CITY OF BOULDER
PLANNING BOARD MEETING AGENDA
DATE: August 28, 2014
TIME: 6 p.m.
PLACE: Council Chambers, 1777 Broadway

**CITY OF BOULDER
PLANNING BOARD AGENDA ITEM
MEETING DATE: August 28, 2014**

AGENDA TITLE: CONTINUATION OF A SITE REVIEW AMENDMENT for development of an existing surface parking lot into a 163 room Residence Inn hotel at the Village Shopping Center, case no. LUR2013-00057. The planned extended stay hotel is located on an approximate 1.65 acre site on the southwest corner of Canyon Boulevard and 26th Street in the Village Shopping Center, 2525 Arapahoe Ave., and 2550 Canyon Blvd. The hotel is proposed to be 128,346 square feet in a 4-5 story building. Below grade parking is proposed under the north wing of the hotel along Canyon Boulevard. Podium parking is proposed on the first floor of the south wing, with surface parking along the interior west property line. The applicant intends to pursue Vested Rights per section 9-2-19, B.R.C. 1981

KEY ISSUE: Do the resubmitted plans address the Planning Board recommended refinements?

Figure 2a: Original Canyon Boulevard setback compared to proposed setback

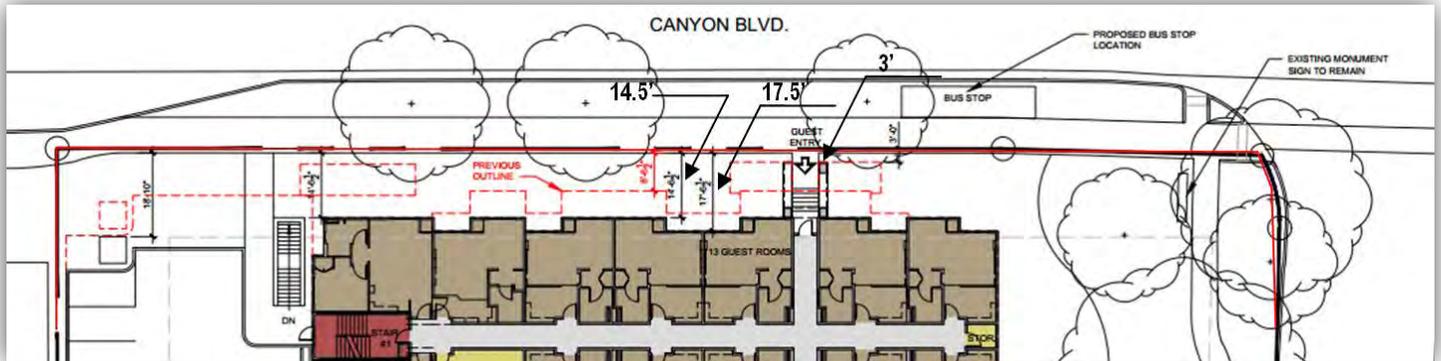
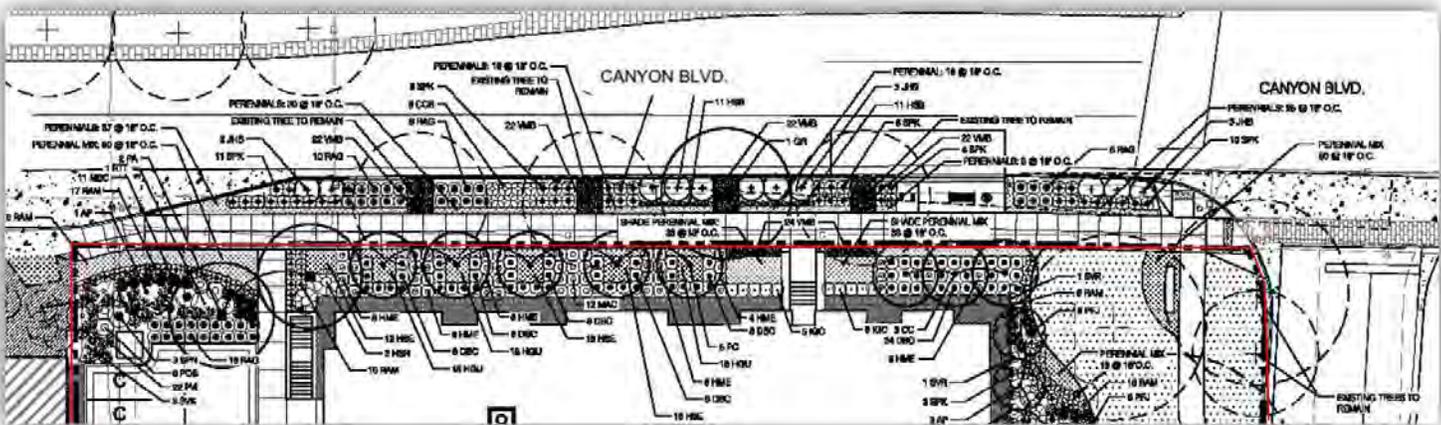
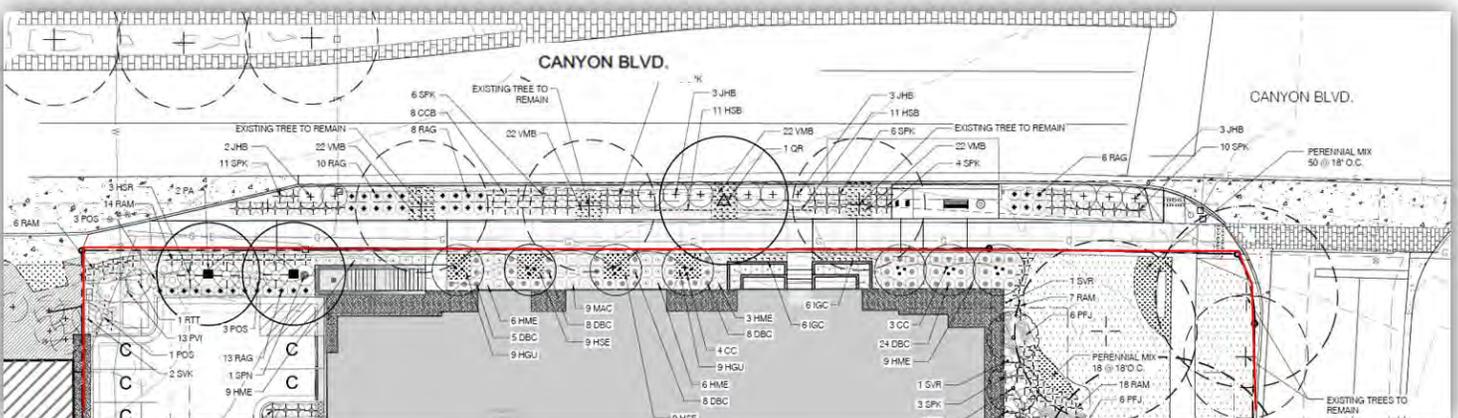
- **Key Issues along the North Side:**
 - Enhance the pedestrian interest along Canyon Boulevard.
 - Add a landscaped amenity area near the northwest section that would screen the parking.
 - Some amount of additional setback on the north side and include enhanced landscaping.
 - Simplification of form and material.
- **Show the feasibility for the future incorporation of renewable energy systems on the building.**

ITEM 2: Regarding the request to increase the building setback along Canyon Boulevard, the setback originally ranged from 8 feet to 13 feet, with a three-foot setback for the entry element along Canyon Boulevard and in response to the request from Planning Board the setback was revised to be a larger setback of 14.5 feet to 17.5 feet. The three foot setback for just entry element remains in place per Planning Board. The stair access to the below grade parking was moved outside of the setback to the west, an additional landscape area was added all along Canyon Boulevard. Within the setback, the applicant has added Pear trees which are taller growing with a more upright habit, creating a canopy of a double row of trees per Planning Board's request. Figure 2a below is the original setback reviewed at the July 17, 2014 Planning Board hearing, Figure 2b is the revised setback, and Figure 2c is a composite illustrating how the setbacks have increased. The applicant also moved the stairway access to the west side of the building which resulted in a loss of three parking spaces which doesn't affect the overall parking reduction.

1. **INCREASE CANYON BLVD. SETBACK & OTHER IMPROVEMENTS - The Canyon Boulevard building setback has been increased by 6 linear feet, enhanced landscaping has been added, stair & transformer have been relocated and covered bus stop provided.** Wider building setback was achieved by reducing the depth of the hotel rooms facing the street. Please see sheets A2.1 & A2.1.1 for dimensioned site plan that show how the additional 6' setback was created. The increased setback area will be used for additional landscaping between the building and the sidewalk. See sheets L5.0, L1.0 & L2.0 for the improved landscape design along Canyon. Also see sheets A5.6 & A5.7 for pedestrian level views of this improved landscaping area along the Canyon frontage.

Figure 3b: Revised south landscape setback with a walkway proposed to cantilever over the detention

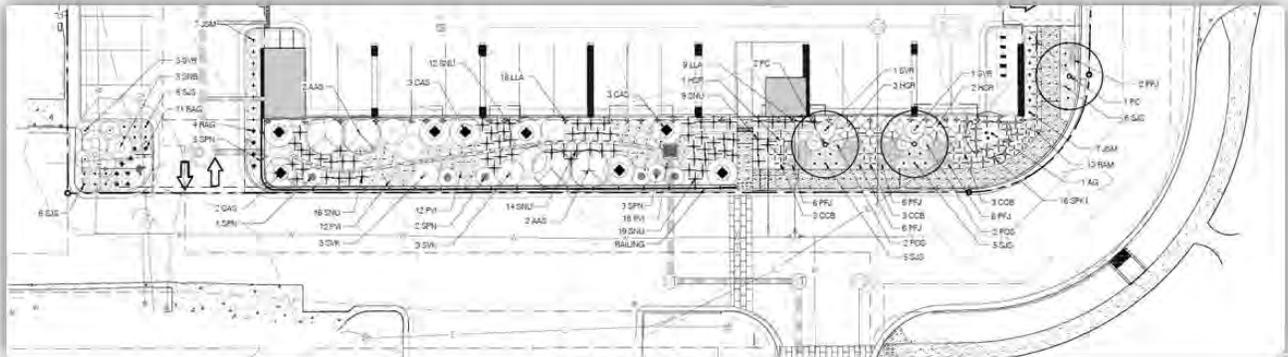
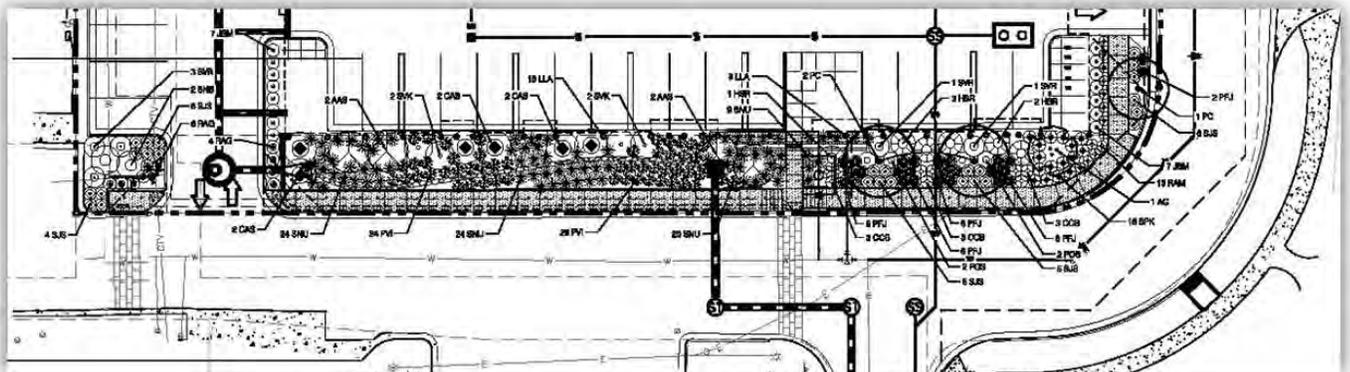
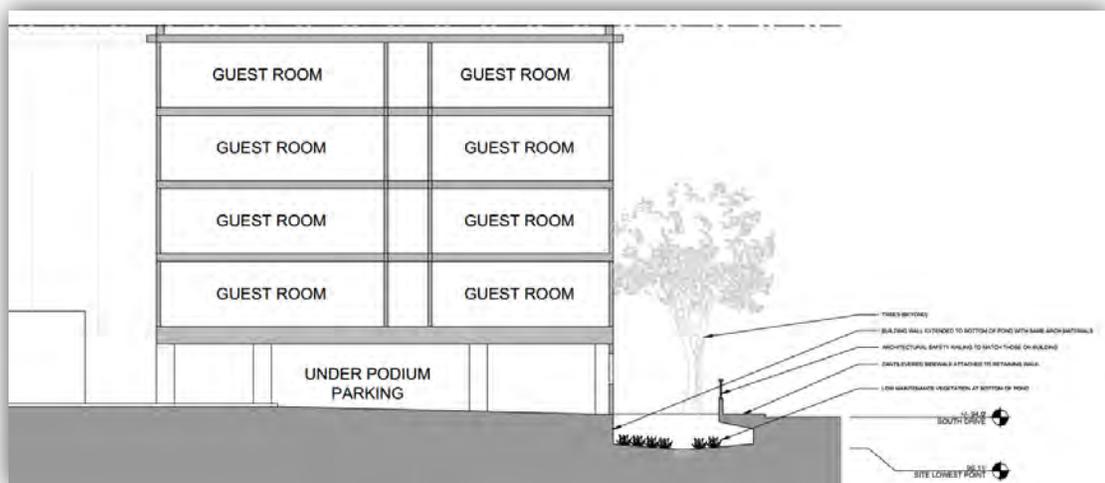
ITEM 3: Regarding the request to place a walkway along the south side of the building, the applicant is now showing a four foot walk along the landscaped area on the south side, with a cross-walk that connects to the walkway adjacent to McGuckin Hardware. For the portion of the walkway that interfaces with the required detention pond, the walkway is planned to be cantilevered such that the ponds requirements for storage capacity remains the same.

Figure 3a illustrates the original plans reviewed by Planning Board, Figure 3b illustrates the revision, and Figure 3c is a cross-section that illustrates the cantilevered walkway.

3. **CONTINUOUS SOUTH SIDEWALK - The south sidewalk located between the hotel and the westward extension of 26th Street is now continuous from the property's southeast corner to its southwest corner.** This was achieved by working with City of Boulder engineering staff to design a cantilevered sidewalk structure over the edge of the project's water quality pond. See sheets L5.0, A4.3 & A5.9 for site plan, section drawings and perspective views showing the design of this improved pedestrian connection.
